Origination Form
Proposed Revisions to a Standard Plans Index

Originator:	Stepp, Richard	Index Number:	715-003
Date:	6/30/2026	Sheet Number(s):	1, 3, 4
E-mail:	richard.stepp@dot.state.fl.us	Index Title:	Utility Conflict Pole

LIGHT POLE - ELEVATION
(Shaft Foundation Shown, Spread Footing Foundation Similar)

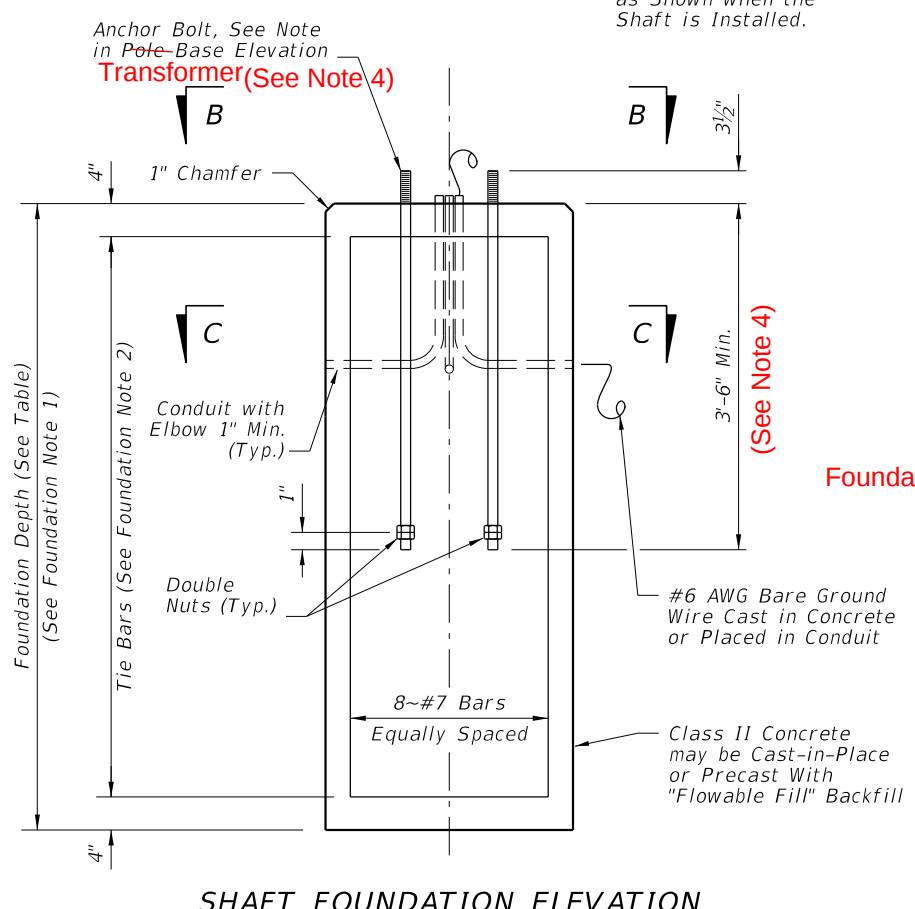
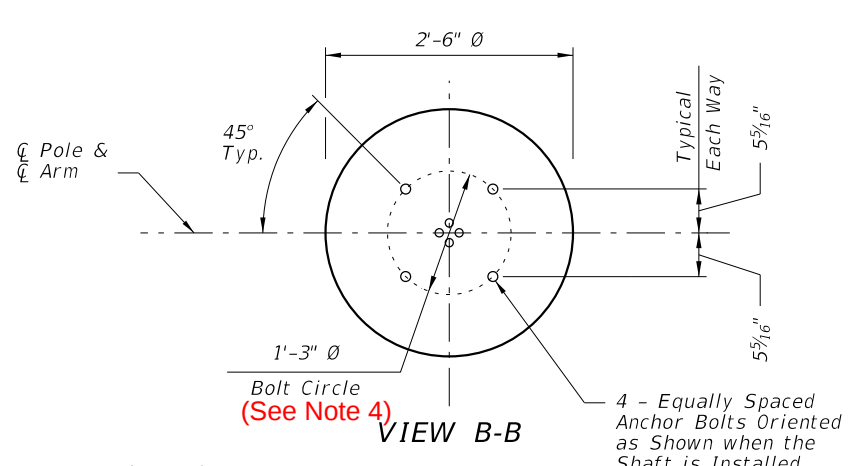
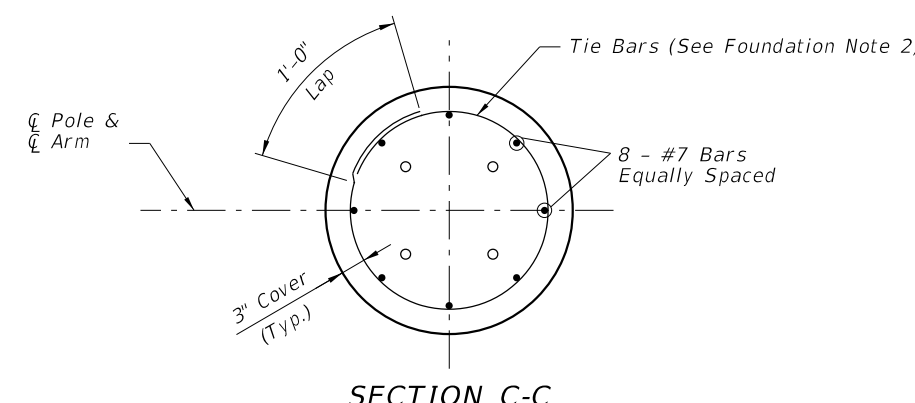
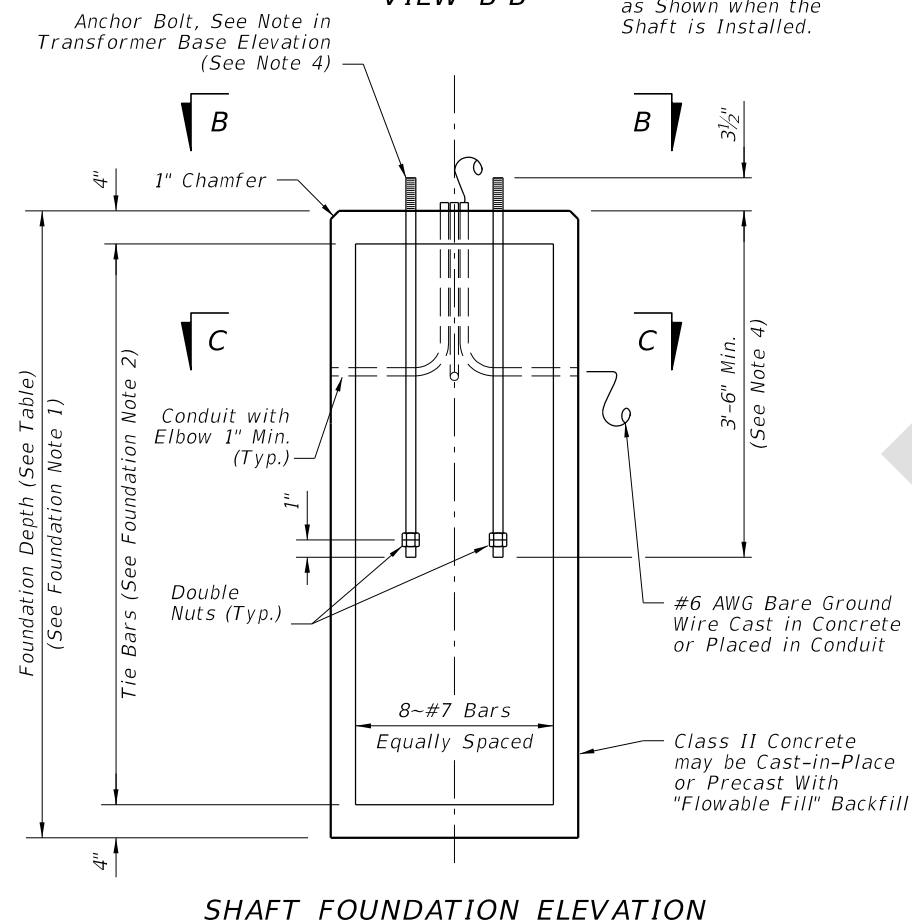
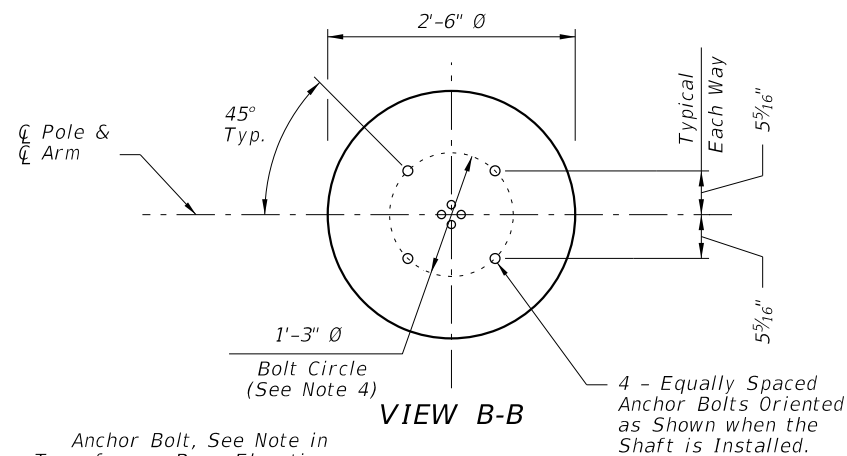
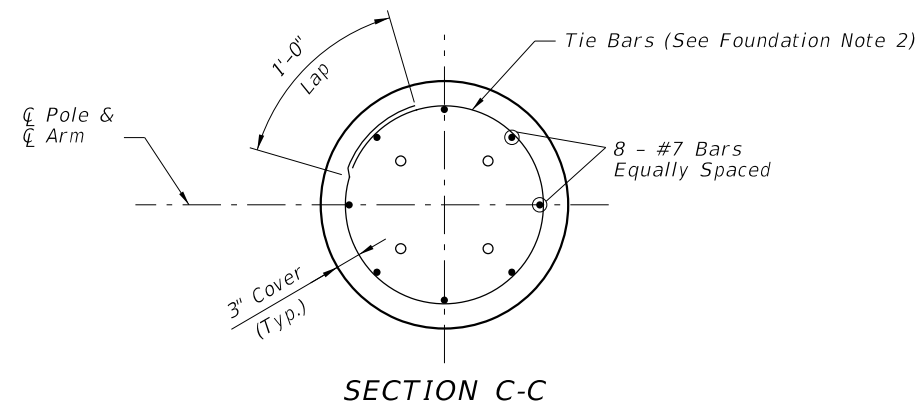
Sheet 1: Updated General Note 2 with new information about shop drawing requirements for frangible bases on the APL; Revised General Note 3 so that a material requirement applies to "Transformer Base" and not all "Frangible Base" options; Revised General Note 6 to address all frangible base options on the APL; Updated the Frangible Base callout in the "Light Pole Base Elevation" to include all other options besides Transformer Base. Sheet 3: Added Note 4 to address requirements for Frangible Base options on the APL; Added Note 4 references in the drawings.
Sheet 4: Added references to Note 4 on Sheet 3 for additional information regarding APL options.

C. Caps and Covers: ASTM B-26, Alloy 319-F
D. Aluminum Weld Material: ER 4043
E. Transformer ~~and Frangible~~ Base Materials: ASTM B26 or ASTM B108, Alloy 356-T6

B. Frangible Base, Base Shoe, and Pole Connection Extrusion Clamp:
a. Certify that the Pole Connection ~~Extrusion Clamp~~, Frangible Transformer Base, and Base Shoe Design are capable of providing the required capacity, assuming a design wind speed of 160 MPH.

b. ~~Certify the Base conforms to the FHWA required AASHTO Frangibility Requirements, tested under NCHRP Report 350 Guidelines (e.g. Akron Foundry TBI-17).~~

Use a frangible base connection as listed on the APL. The base must be recognized by

as being successfully crash tested or MASH (Task Force 13, LBT08 Transformer Base shown, others similar).

C. Caps and Covers: ASTM B-26, Alloy 319-F
D. Aluminum Weld Material: ER 4043
E. Transformer Base Materials: ASTM B26 or ASTM B108, Alloy 356-T6
F. Base Bolts, Nuts and Washers:

B. Frangible Base, Base Shoe, and Pole Connection Extrusion Clamp:
a. Certify that the Pole Connection Clamp, Frangible Transformer Base, and Base Shoe Design are capable of providing the required capacity, assuming a design wind speed of 160 MPH.

b. Use a frangible base connection as listed on the APL. The base must be recognized by FHWA as being successfully crash tested under NCHRP Report 350 or MASH Guidelines (Tash Force 13, LBT08 Transformer Base shown, others similar).
